Access Compliance Report

Public Rights-of-Way

(Curb Ramps)

Intersection ID: 42914	Main Street: CROSSWALK_DR	Cross Street: FOREST_CROSS_DR	Location: S
ADA ID: 194FF995C324	Ramp Type: PerpDiag	Initial Pass/Fail: Fail	Overall Compliance: No
Severity Score: 10			
Codes/Mitigation Info/Possible Solution		Field Measurements/Component Compliance

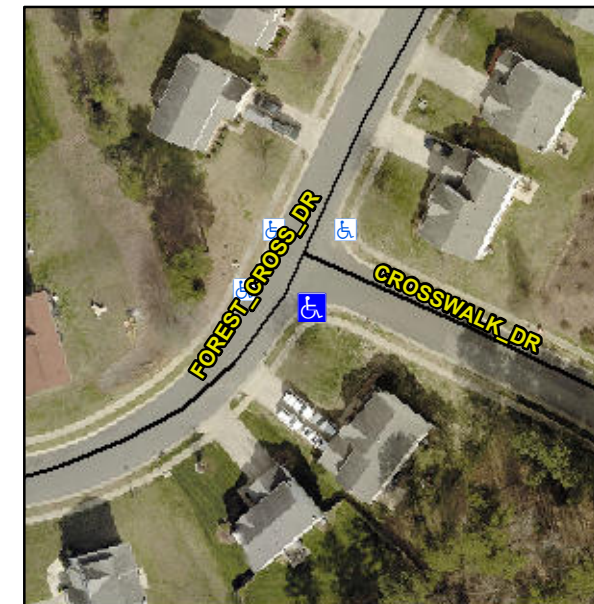
Not Found, R304.5.1, R304.5.3

Compliance	Description	Data	Compliance	Description	Data
N/A	Ramp Length (in)	47.5	Yes	Ramp Slope (%)	6.0
No	Ramp Width (in)	46.5	No	Ramp XSlope (%)	2.5
N/A	Flare Type LT	N/A	N/A	Flare Type RT	N/A
N/A	Flare Slope LT (%)	N/A	N/A	Flare Slope RT (%)	N/A
N/A	Flare Traversable LT?	N/A	N/A	Flare Traversable RT?	N/A
N/A	Landing Length (in)	N/A	N/A	DWS Provided?	N/A
N/A	Landing Width (in)	N/A	N/A	DWS Contrast?	N/A
N/A	Landing Slope (%)	N/A	N/A	DWS Length (in)	N/A
N/A	Landing X Slope (%)	N/A	N/A	DWS Full Width?	N/A
N/A	Landing Curb? (Y/N)	N/A	N/A	DWS Offset (in)	N/A
N/A	Shared Landing?	N/A			
N/A	Gutter Ponding?	N/A	N/A	Gutter Slope (%)	N/A
N/A	Gutter Lip Ht (in)	N/A	N/A	Gutter X Slope (%)	N/A
N/A	Painted X Walk1?	No	N/A	Painted X Walk2?	No
	X Walk 1 Direction	To NE		X Walk 2 Direction	To NW
N/A	X Walk 1 Width (in)	N/A	N/A	X Walk 2 Width (in)	N/A
	X Walk 1 Slope (%)	5.4		X Walk 2 Slope (%)	5.0
	X Walk 1 X Slope (%)	0.1		X Walk 2 X Slope (%)	4.1

Remove & Replace Curb Ramp With Two New Directional Ramps or Equivalent.
